SUBJECT:			No:	TSB-19-52A-005		
SECOND ROW CENTER SEAT BELT			DATE: December 2019			
				MODEL: 2014-19 Outlander, 2018-19 Outlander PHEV		
CIRCULATE TO:	[] GENERAL MANAGER	[X] PARTS MANAGER		[X] TECHNICIAN		
[X] SERVICE ADVISOR	[X] SERVICE MANAGER	[X] WARRANTY PROCESSO	DR	[] SALES MANAGER

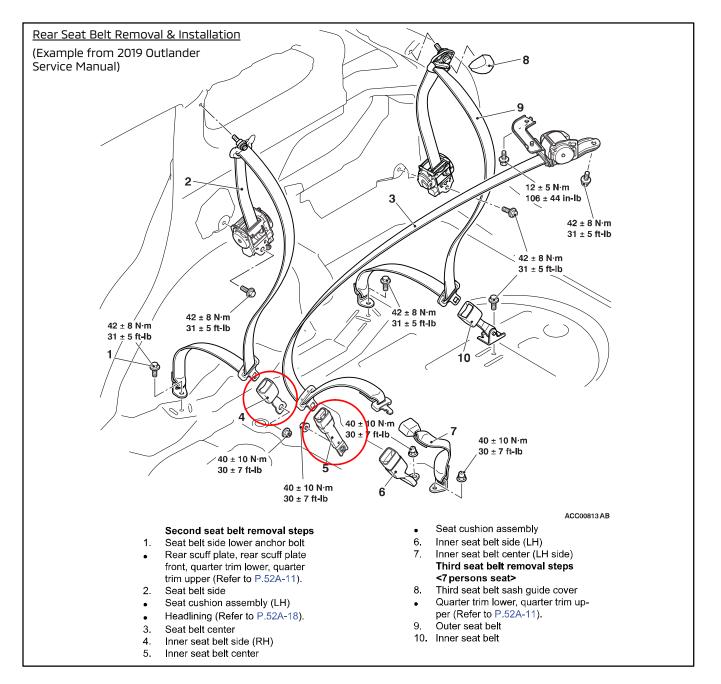
A customer may report that the second row right side seat belt buckle cover has come off, and in some instances, prevent the second row right side seat belt tongue from latching into the buckle when the internal buckle components have fallen off.

This may be caused by repeatedly folding the second row right side seat back while the center seat belt buckle is positioned on top of the right side seat belt buckle.

The second row center seat belt buckle length has been shortened by 14 mm to prevent the center seat belt buckle from covering the right side seat belt buckle.

This TSB instructs dealers to replace the second row right side seat belt buckle with a new part and install the countermeasure second row center seat belt buckle.
